ADDENDUM NO. 1

**HANOVER COMMUNITY SCHOOL CORPORATION - NEW RESOURCE
CENTER AND RELATED WORK
Cedar Lake, IN 46303**

This Addendum consists of page ADD 1-1 and attached Addendum No. 1 from Gibraltar Design dated May 27, 2021 and consisting of 5 pages and 48 drawings.

SI 101

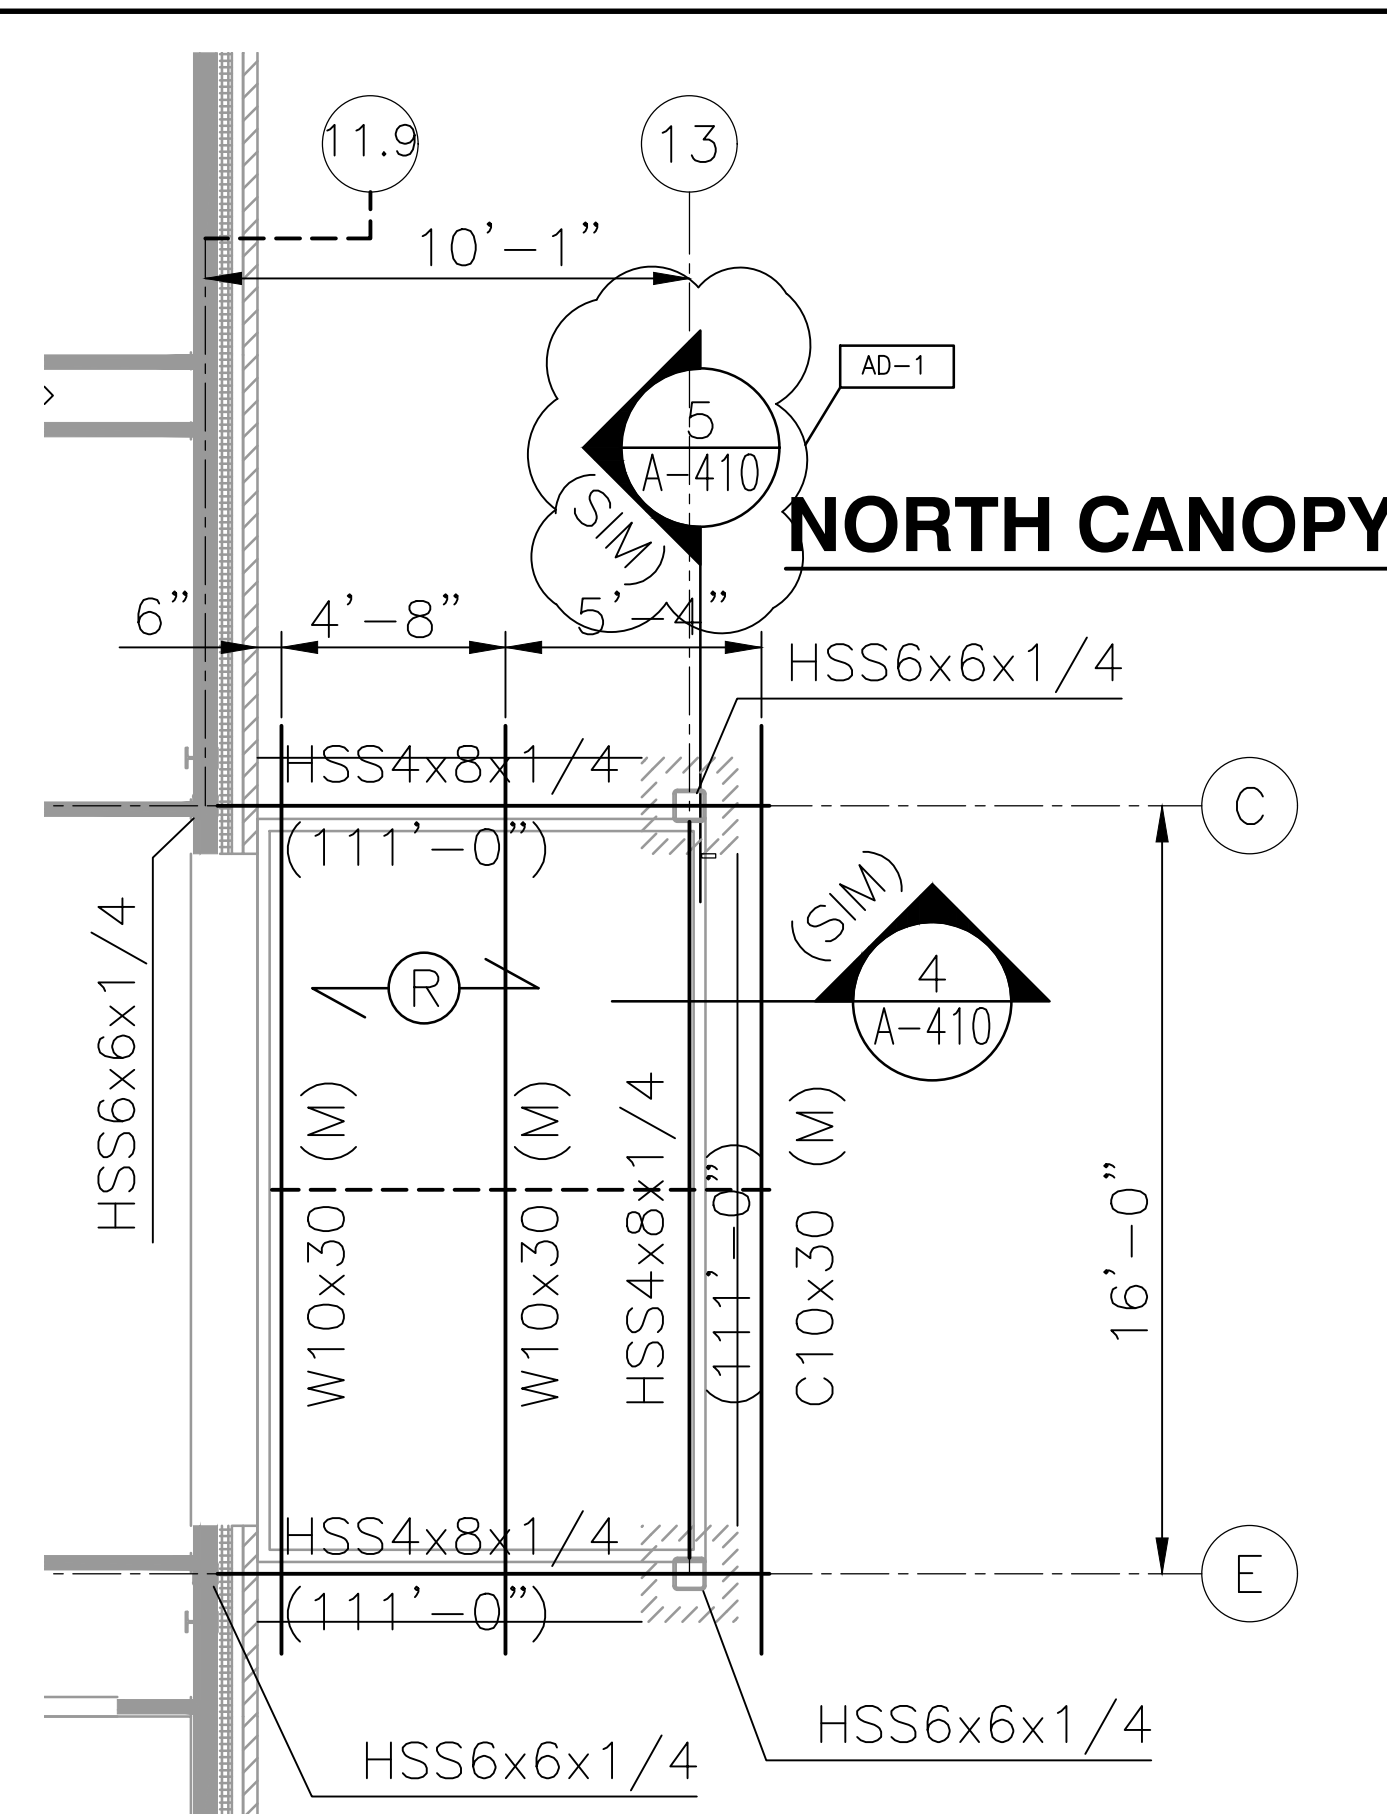
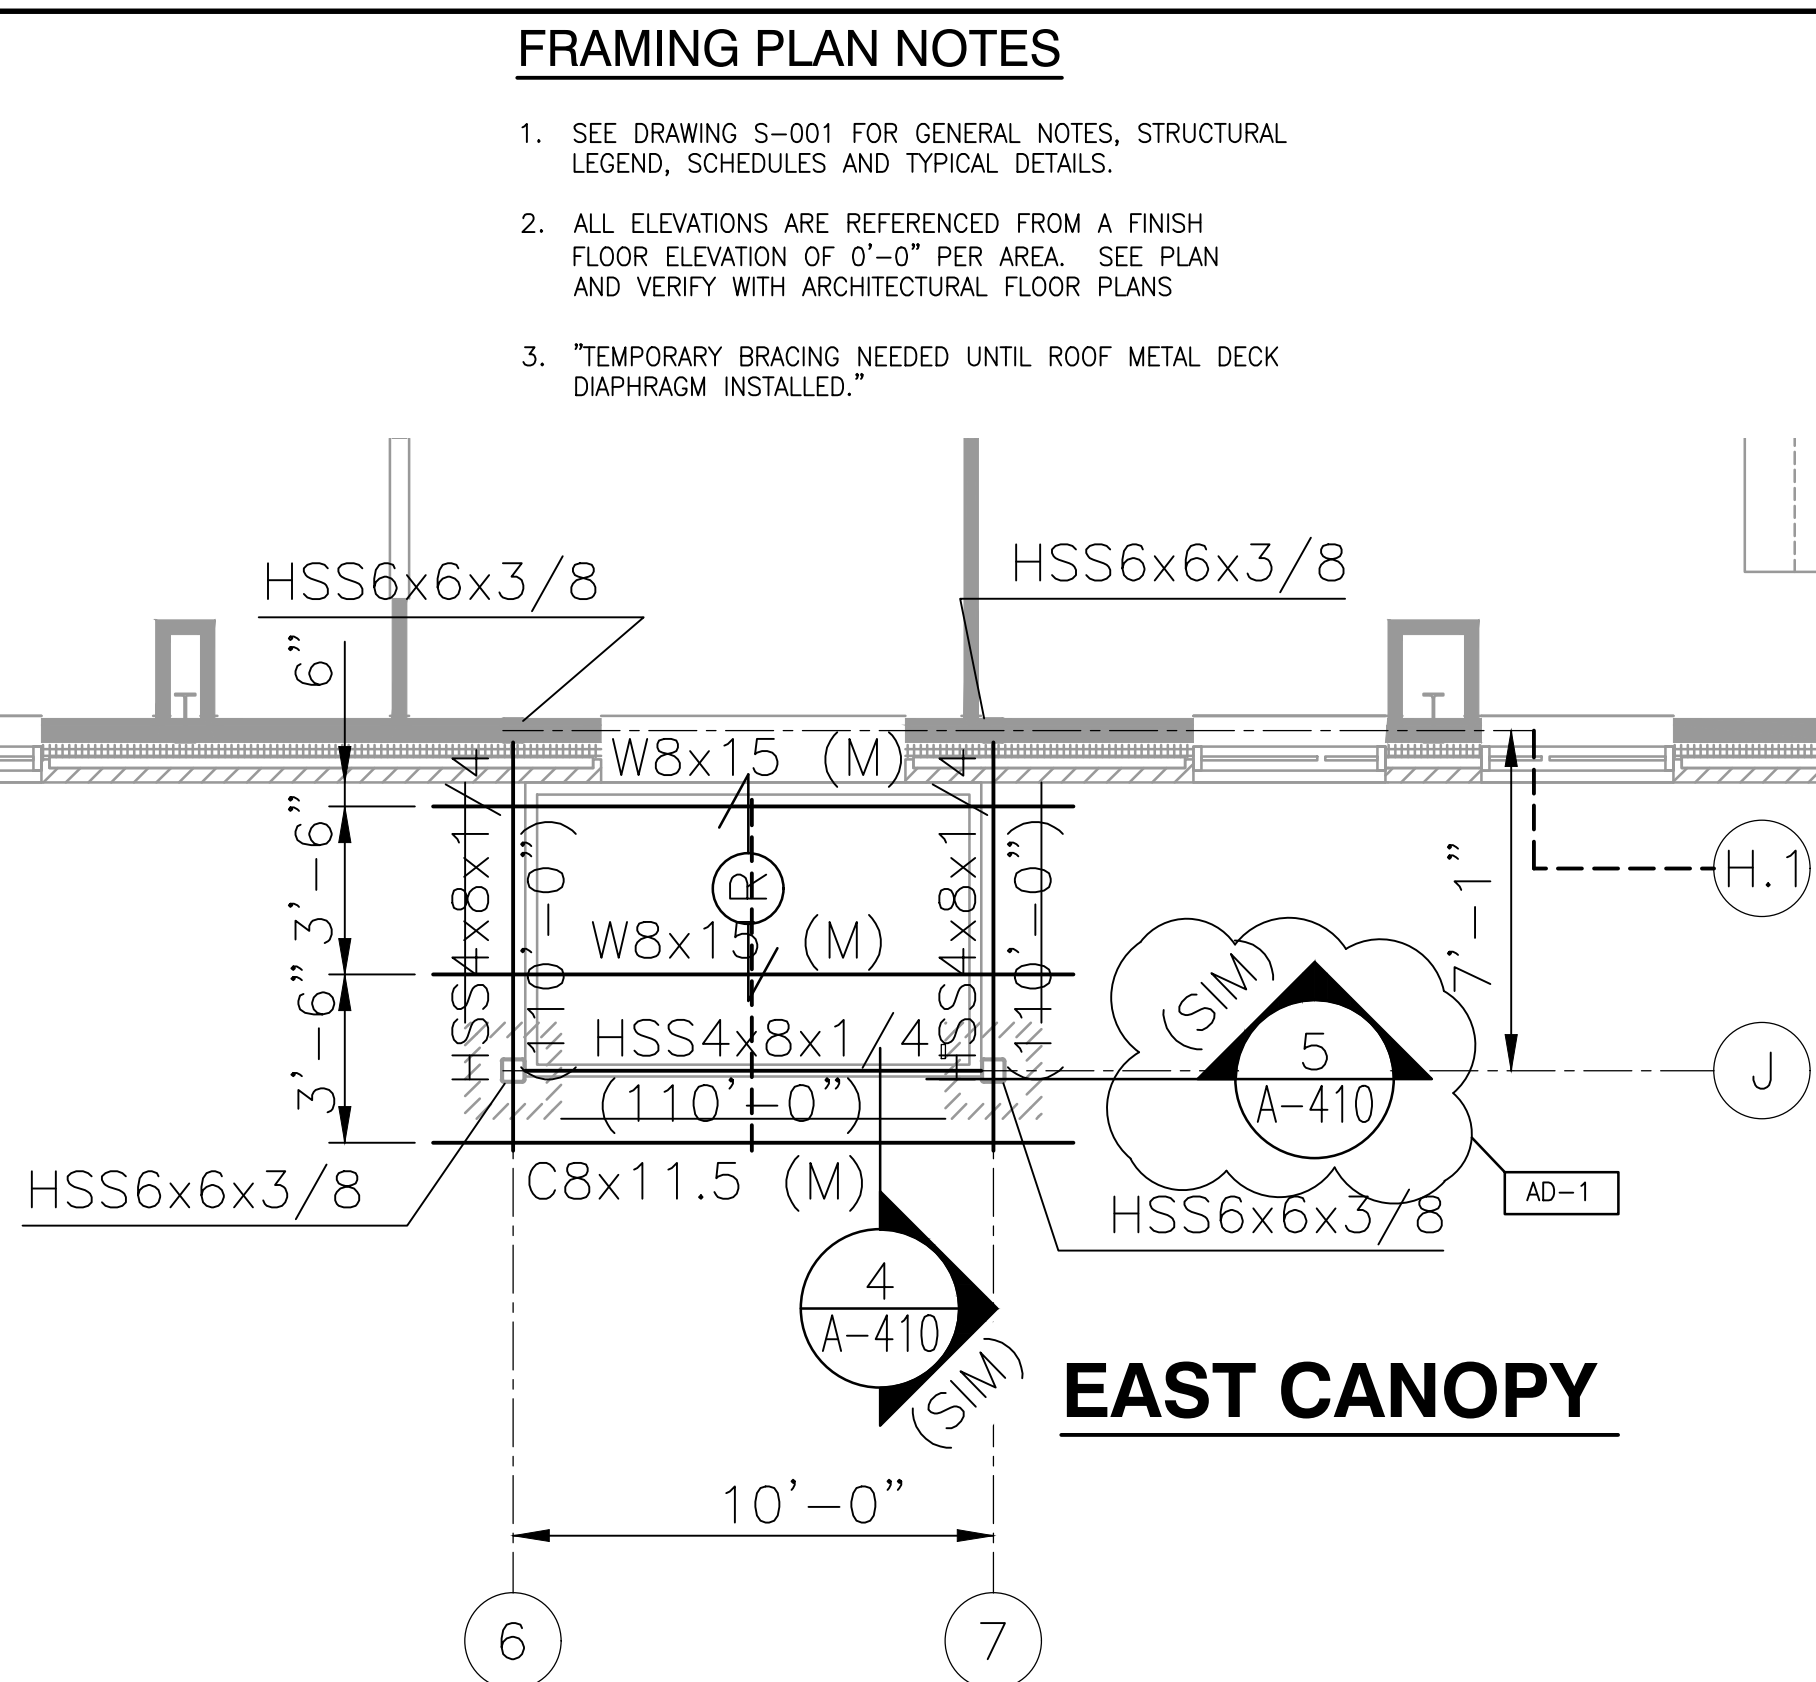
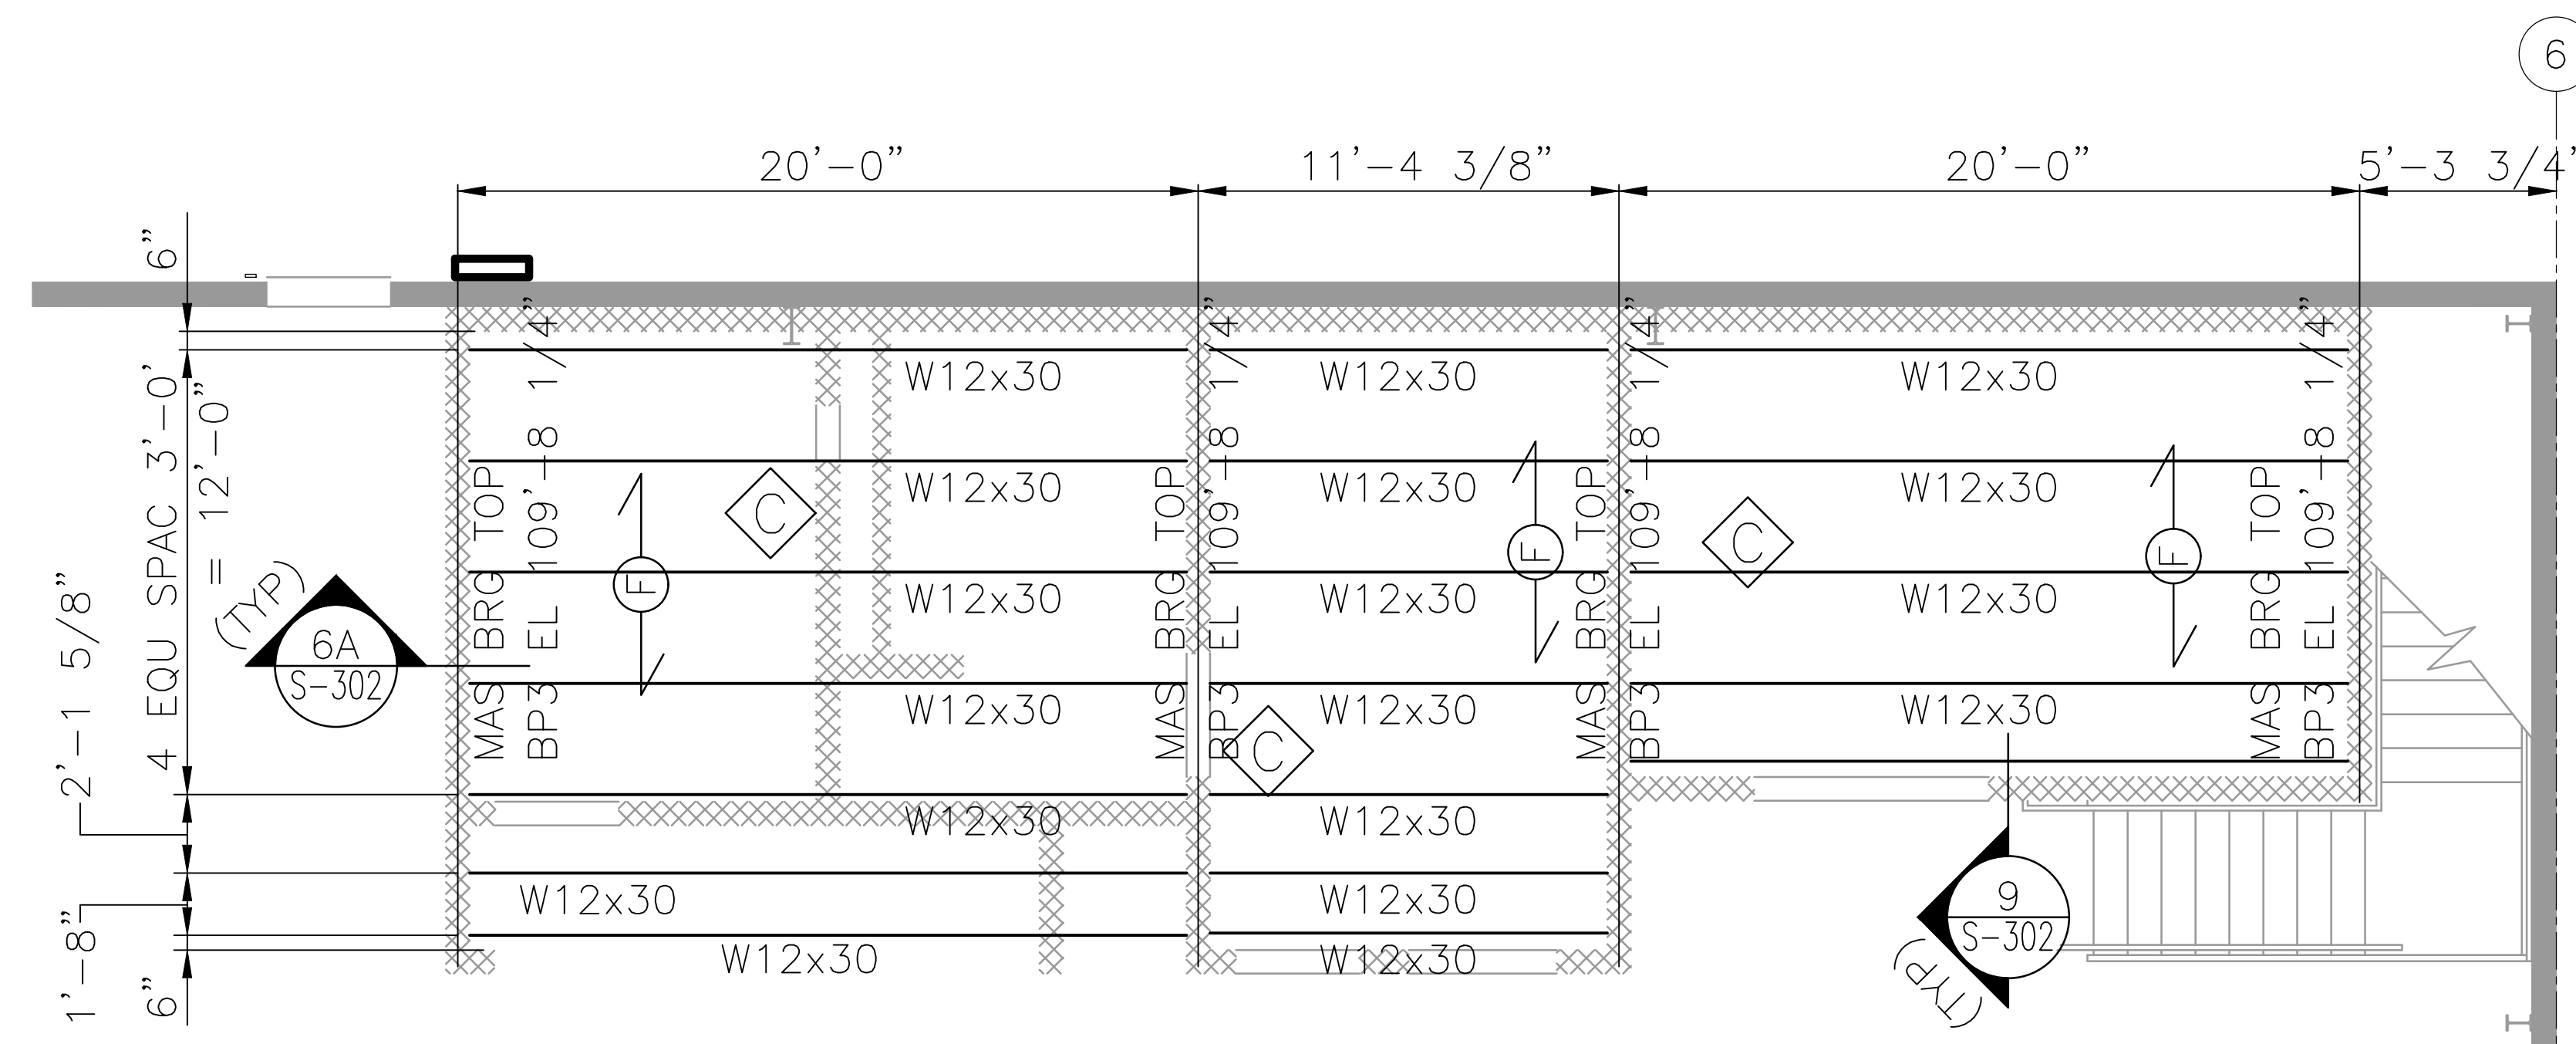
7. Sheet LB101

1. Revise section cuts layout for Resource Center Building – (3) Canopy Framing Plans.
2. Revise section cut label for “Maintenance Building – Lintel Plan” and Bus Garage Building – Canopy Roof Framing Plan”.
3. Revise lintel plan layout for “Bus Garage Building – Lintel Plan”.
